ROUTE 9A - WEST STREET PROMENADE PROJECT  
 RECONSTRUCTION OF RT. 9A-WEST ST. (BATTERY PLACE TO CHAMBERS ST.)  
 MANHATTAN, NEW YORK COUNTY

FIELD CHANGE SHEETS (JUNE 6, 2012)

BATTERY PARK UNDERPASS APPROACH WALLS MODIFICATIONS

BATTERY PARK UNDERPASS  
 APPROACH WALLS  
 DETAIL ELEVATIONS - 1

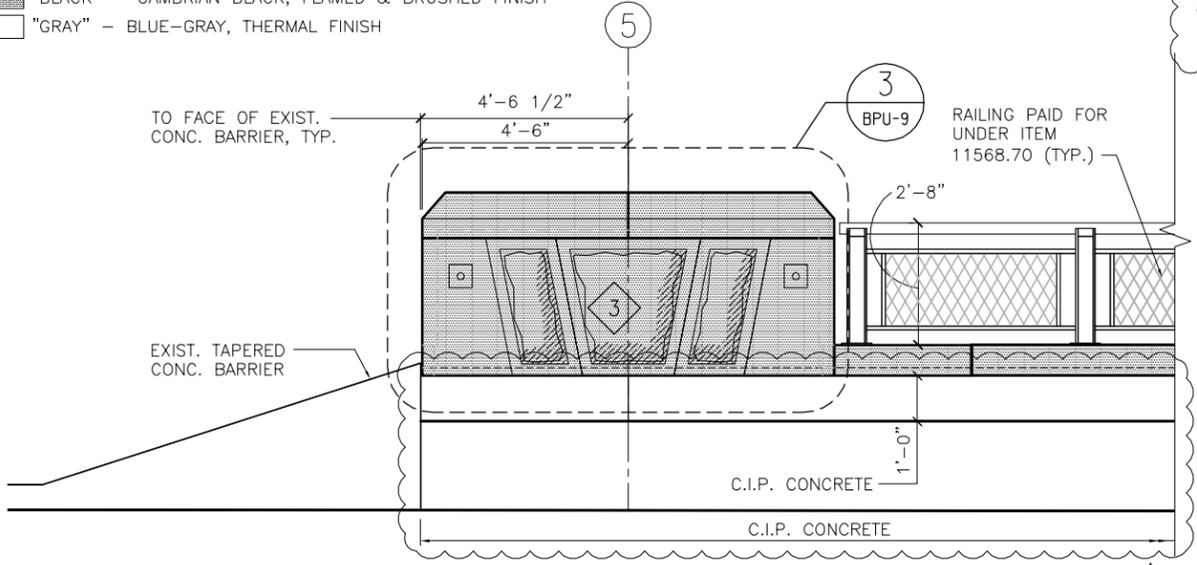
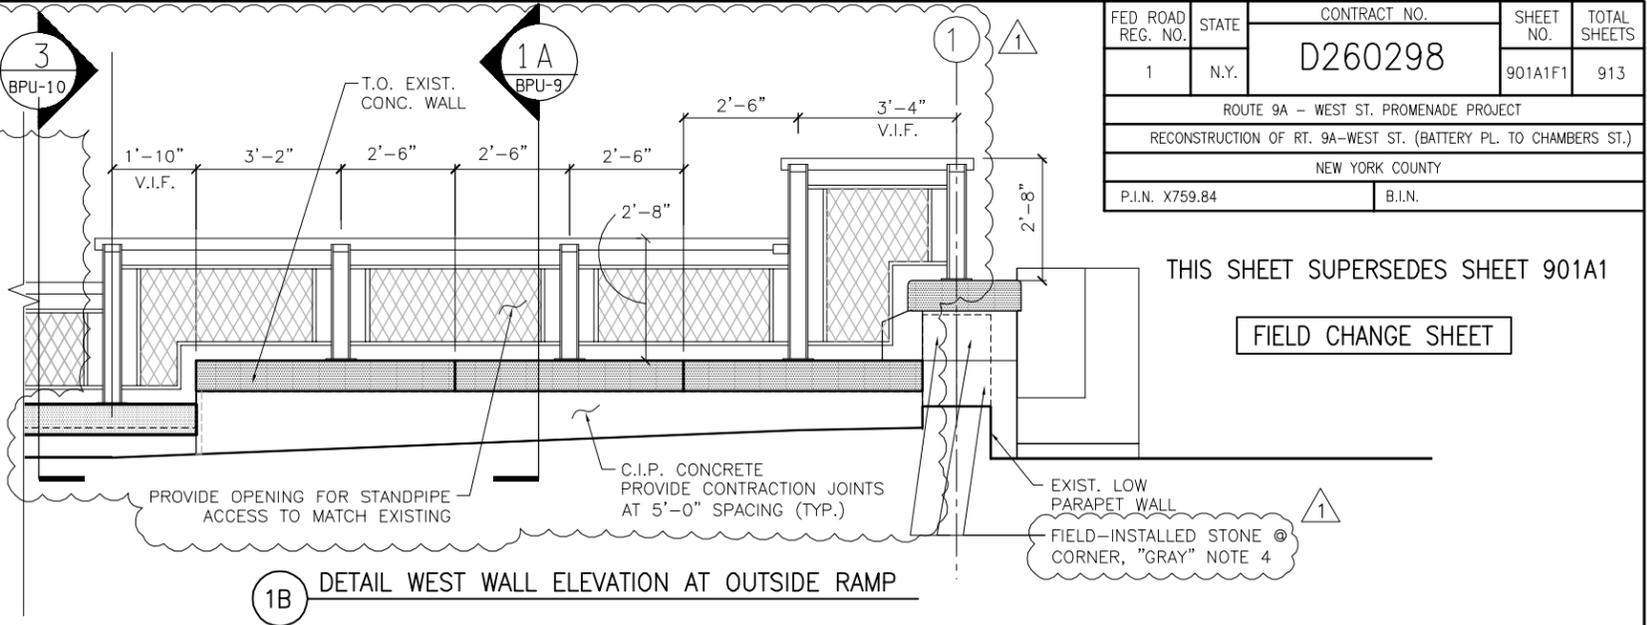
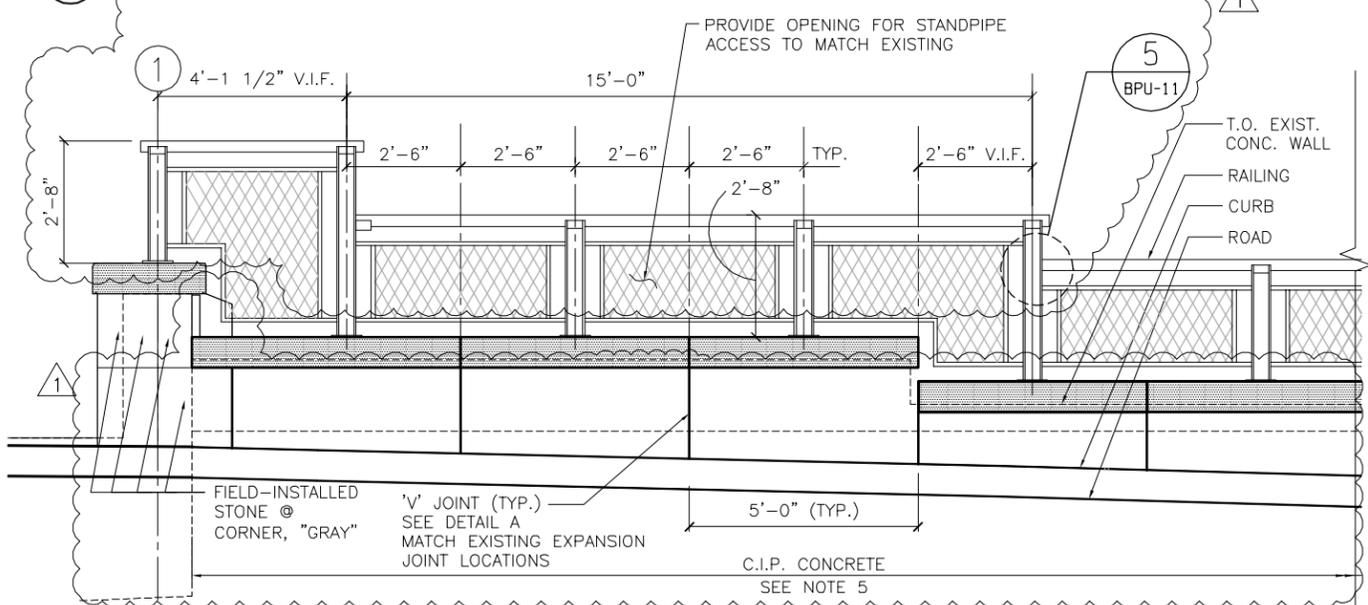
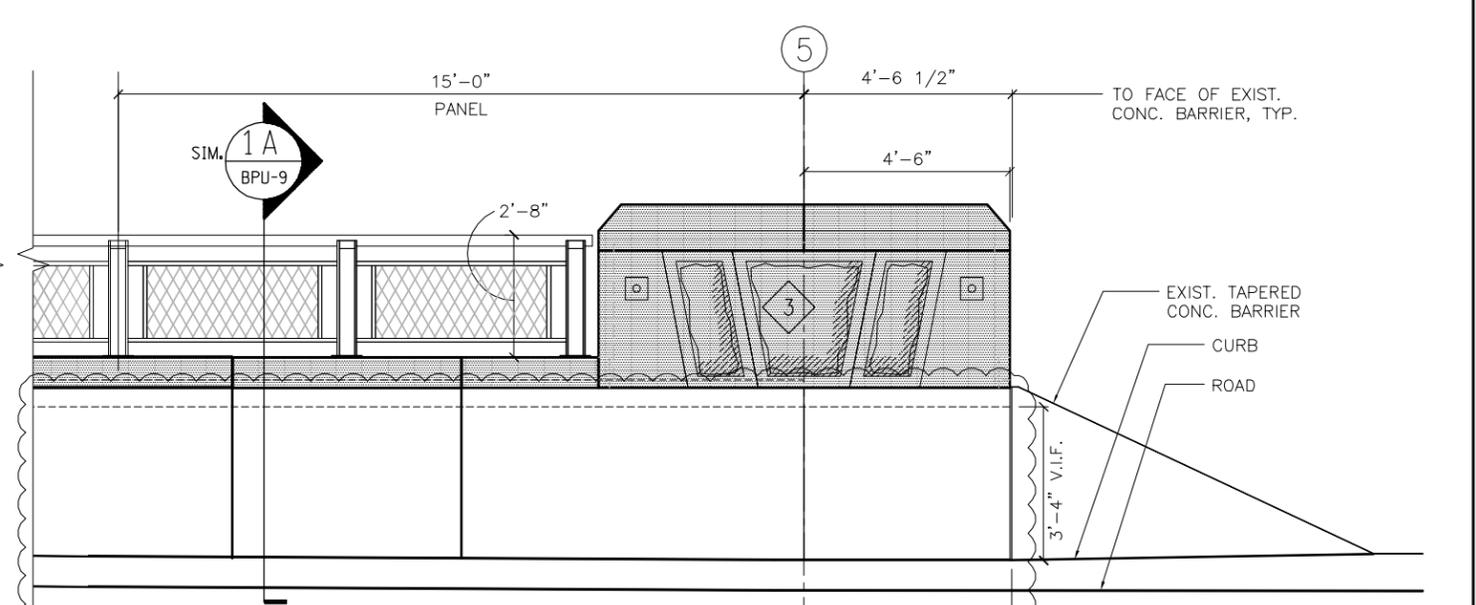
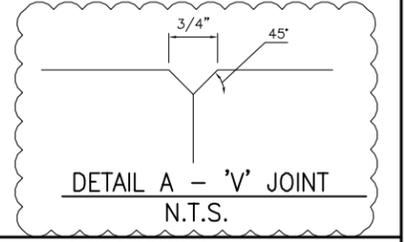
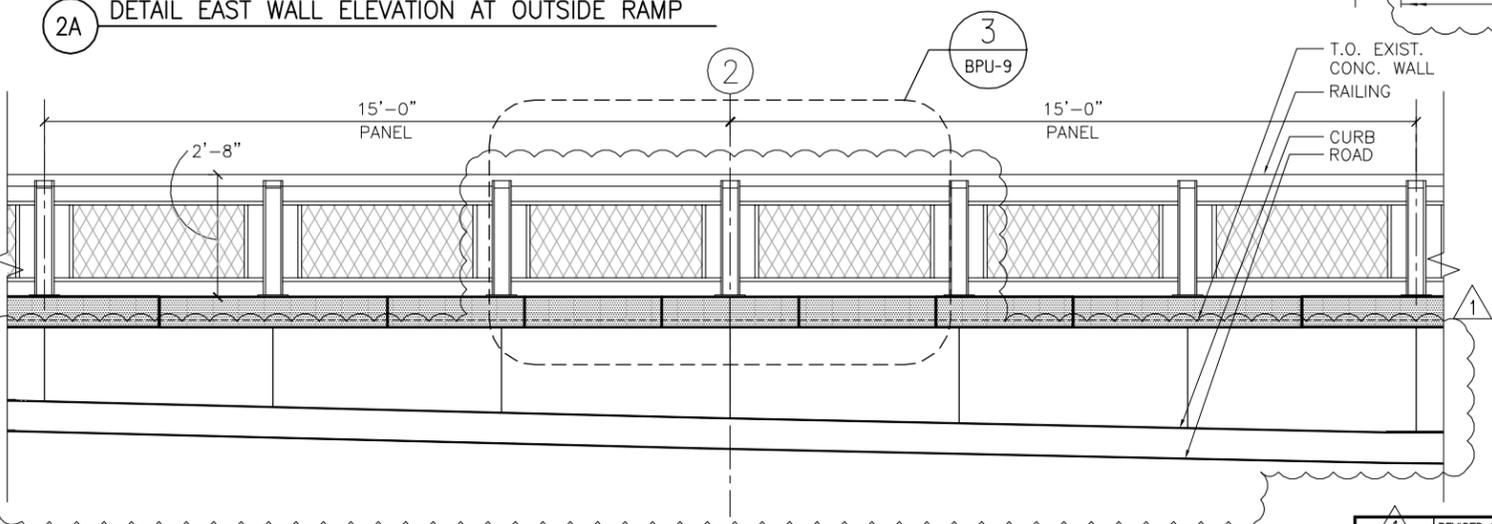
1	REVISED NOTE, CHANGED TO C.I.P. CONCRETE, ADDED DETAIL A, DELETED PILASTER HEADS	05/08/2012
NO.	DESCRIPTIONS	DATE
	REVISIONS

- NOTES:**
- EXISTING CONDUITS TO BE TEMPORARILY SUPPORTED TO ALLOW INSTALLATION OF PANELS.
  - SEE DWG BPU-14 FOR TYPES OF STONE VENEER PANELS.
  - PRECAST PANELS, PILASTERS STEMS, COPING STONES, AND C.I.P. STONE PAID FOR UNDER ITEM 40560.3112. PILASTER CAPS TO BE PAID FOR UNDER ITEM 40560.36.
  - USE ST. STL. DOWELS @ BOTTOM (2 PER STONE) & ST. STL. STRAP/WIRE HOOK /ROD CLAMP @ TOP (2 PER STONE), TYP.
  - C.I.P. CONCRETE PAID FOR UNDER ITEM 40555.7294. FORM LINER TREATMENT SHALL BE #T316 FINE SANDBLAST BY CUSTOMROCK OR APPROVED EQUAL.

BATTERY PARK UNDERPASS  
 APPROACH WALLS  
 DETAIL ELEVATIONS - 2

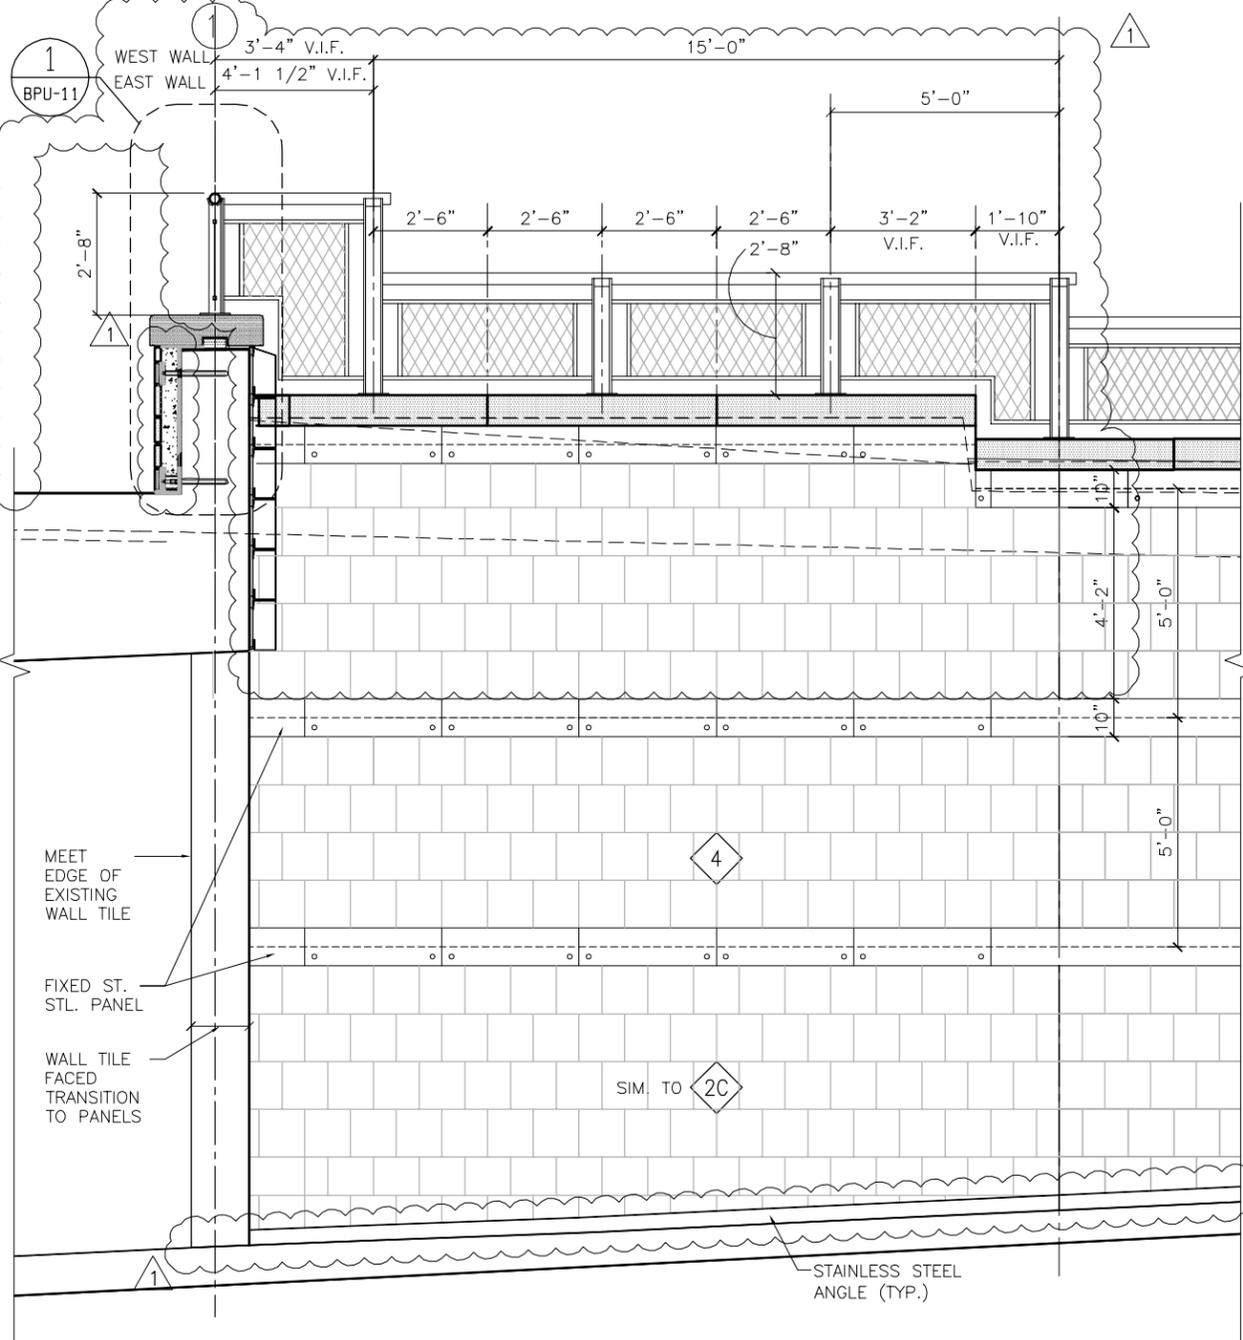
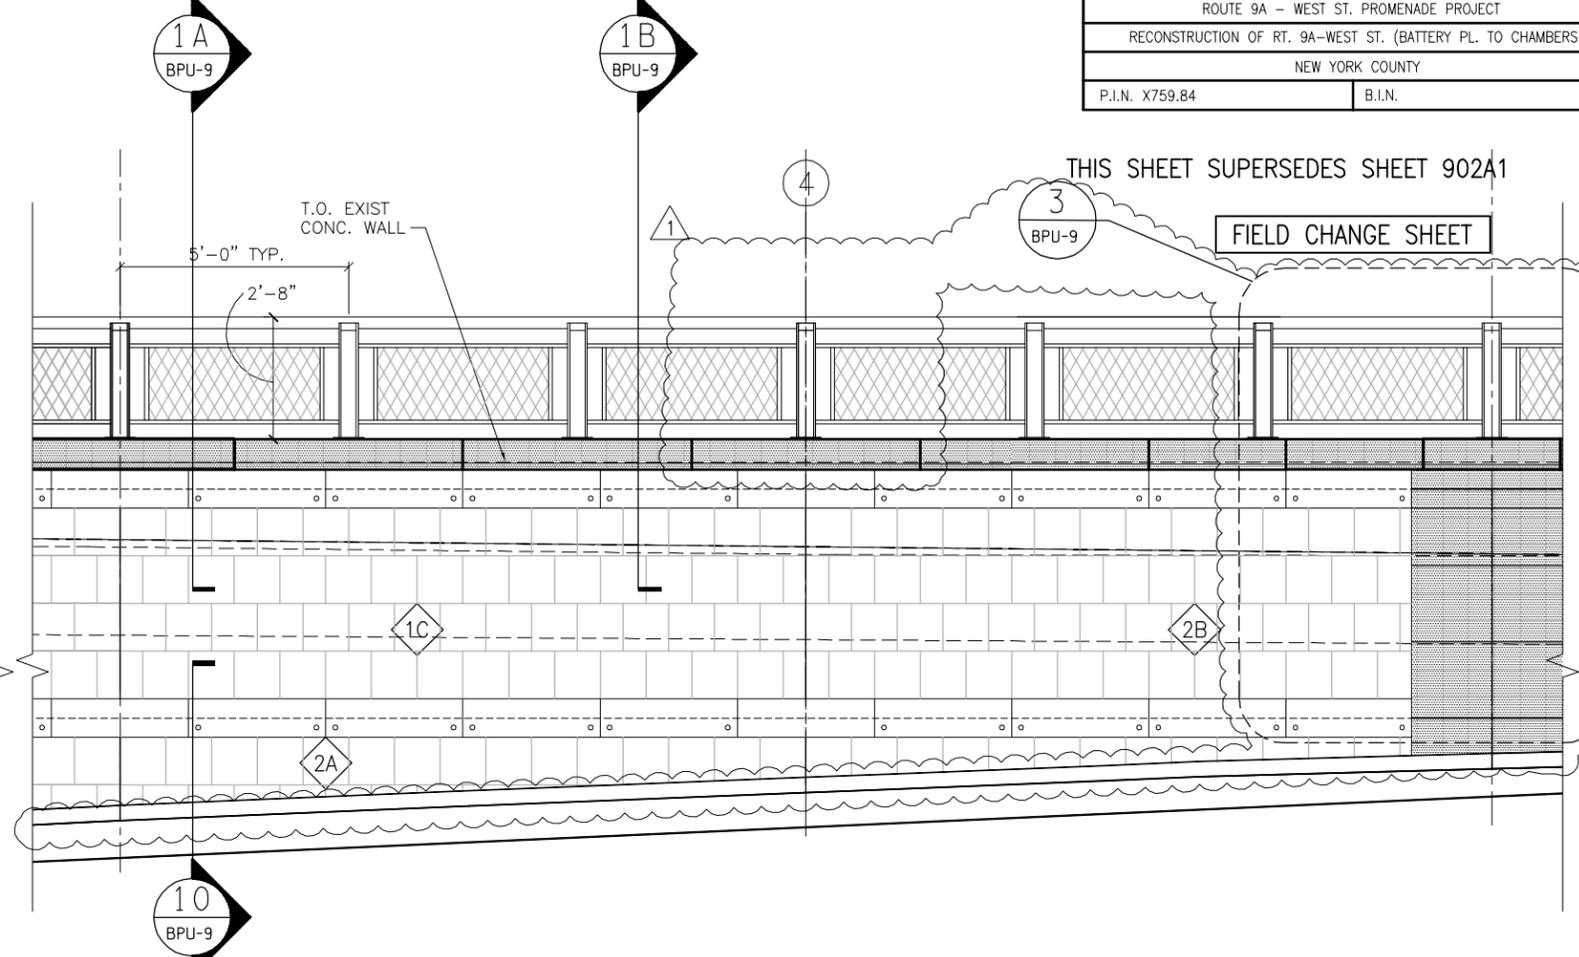
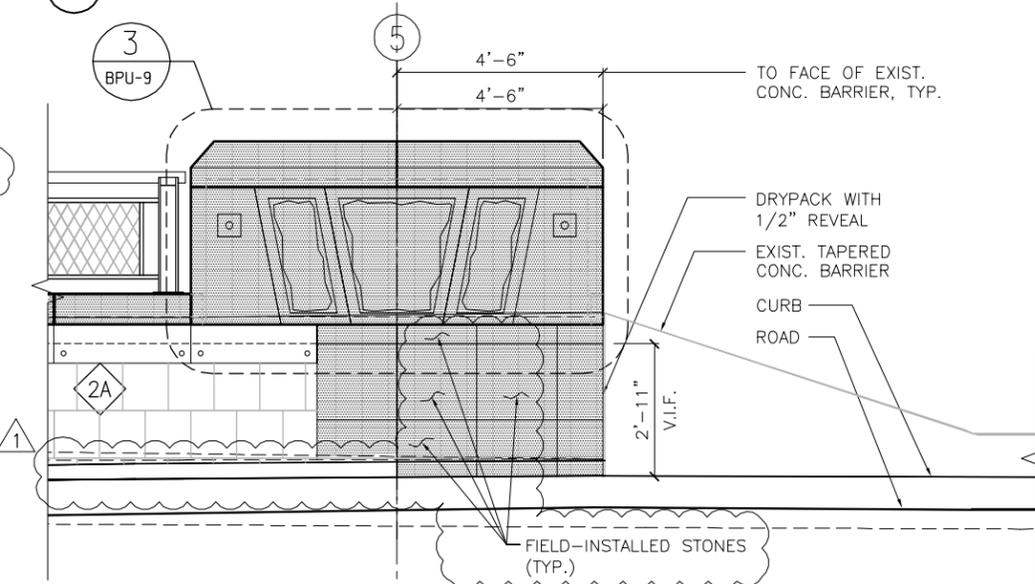
NO.	DESCRIPTIONS	DATE
1	CHANGED TO S.S. ANGLE AND WALL ELEVATION, DELETED PILASTER HEADS	05/08/2012
	REVISIONS

1 DETAIL PORTAL ELEVATION AT INSIDE RAMP

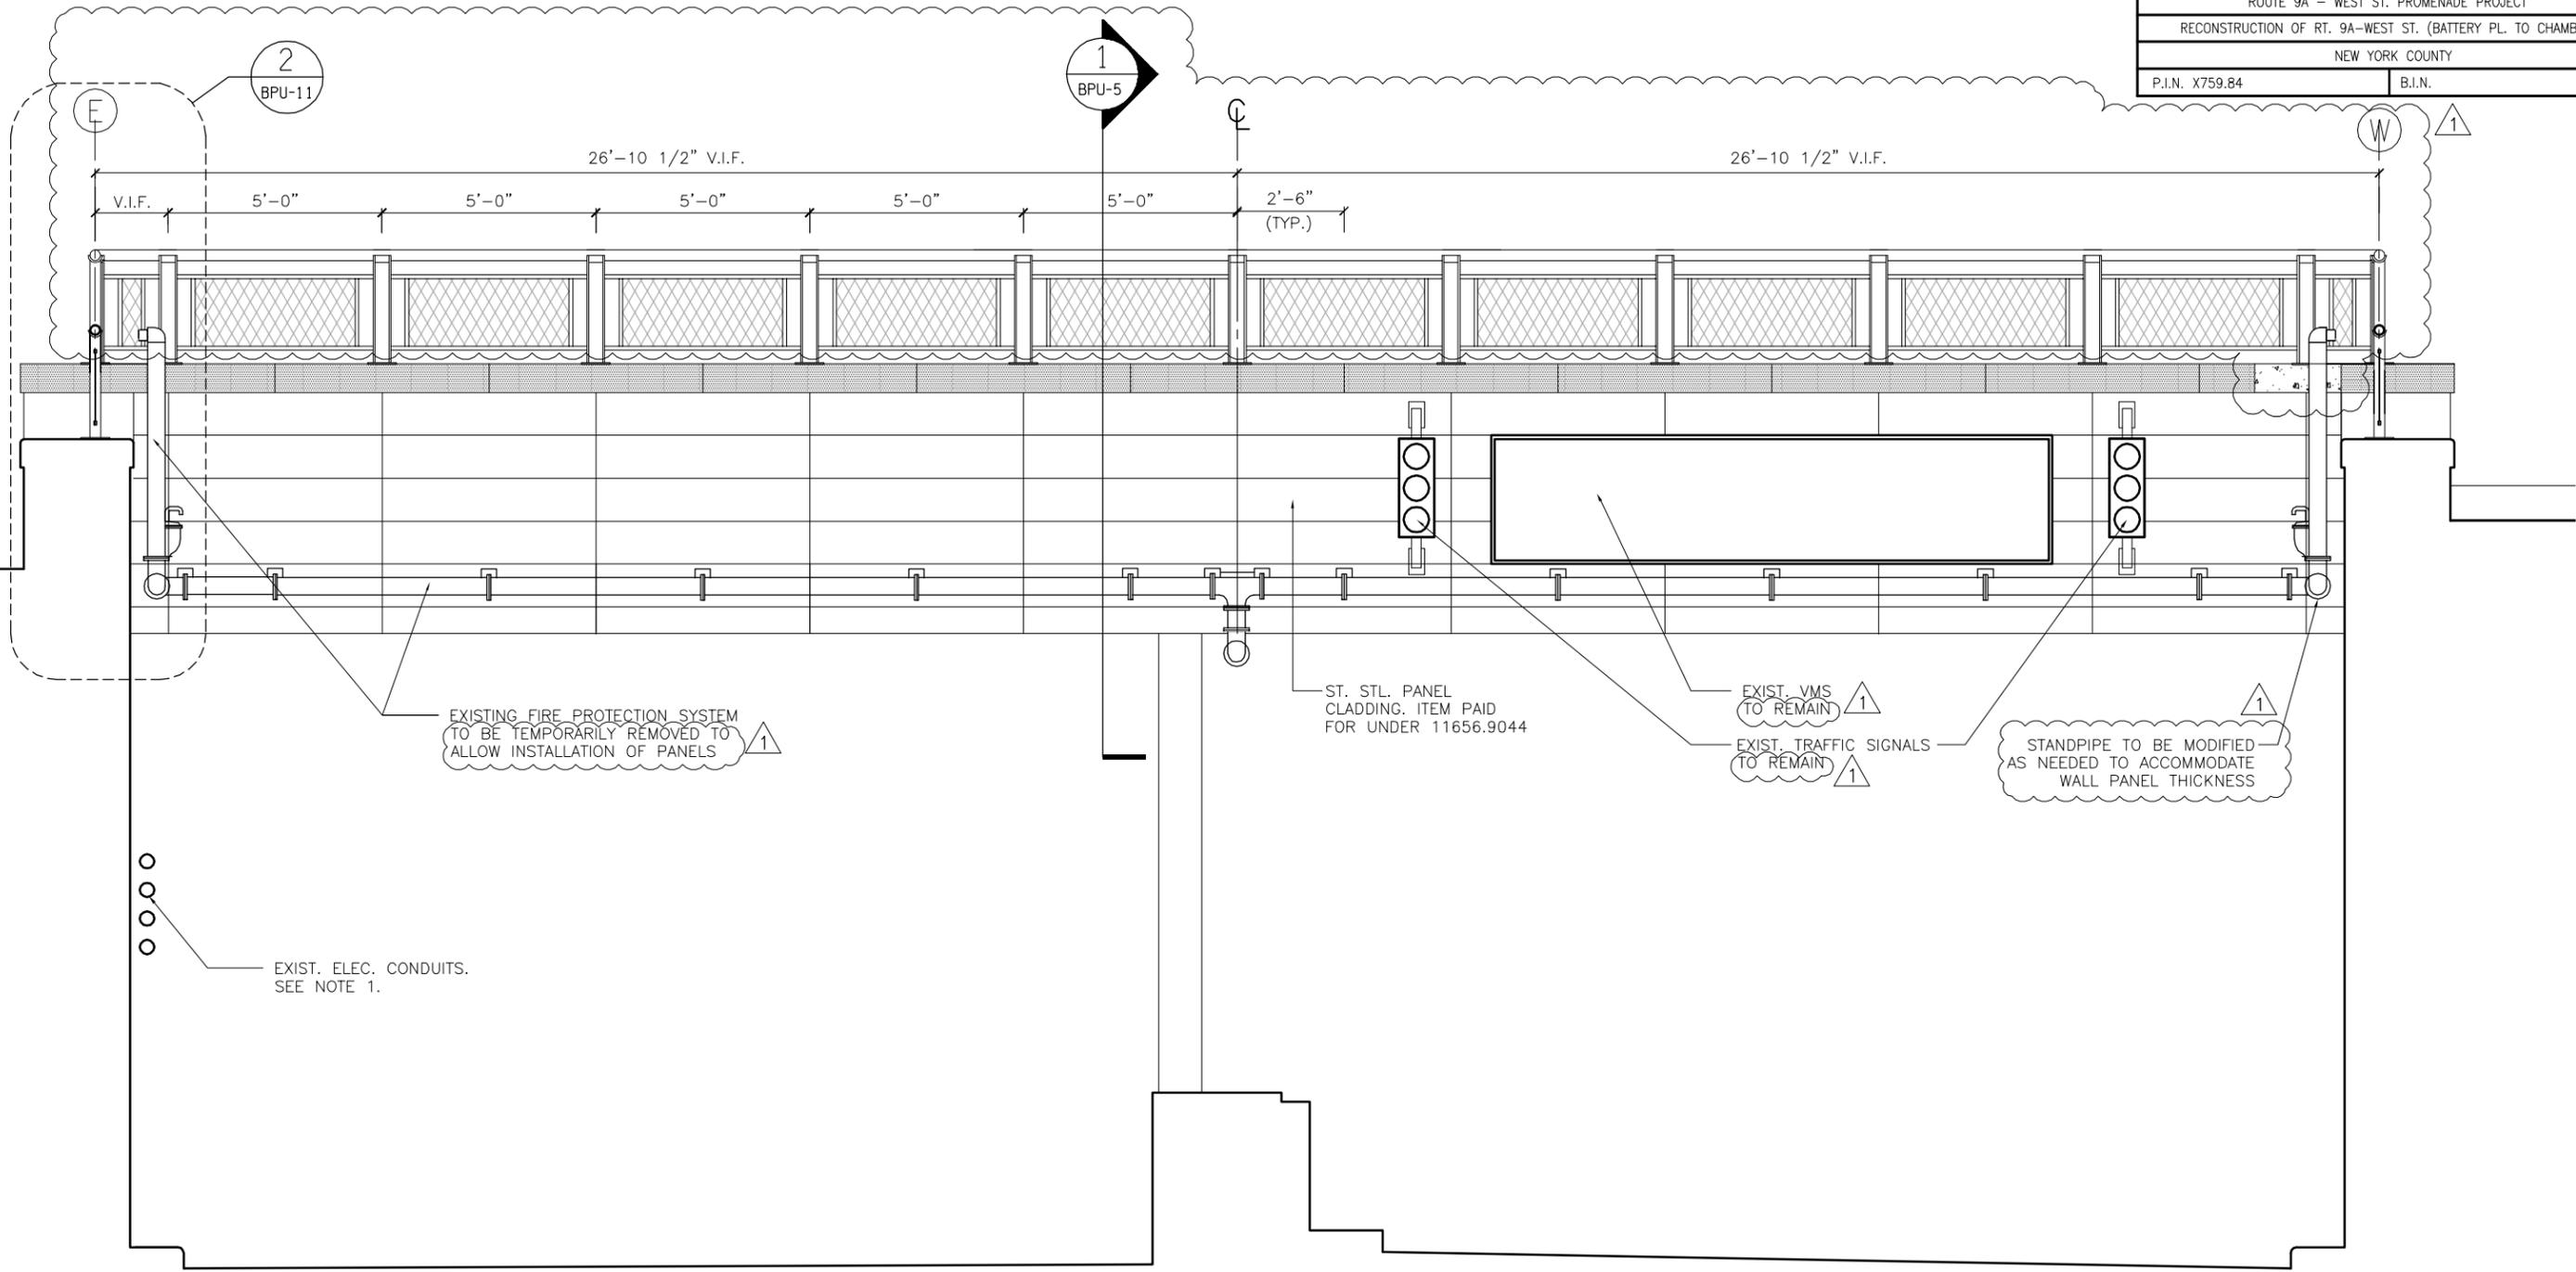
NO.	DESCRIPTIONS REVISIONS	DATE
1	CHANGED NOTE AND PANELS	05/08/2012

1. EXISTING CONDUITS TO BE RELOCATED.
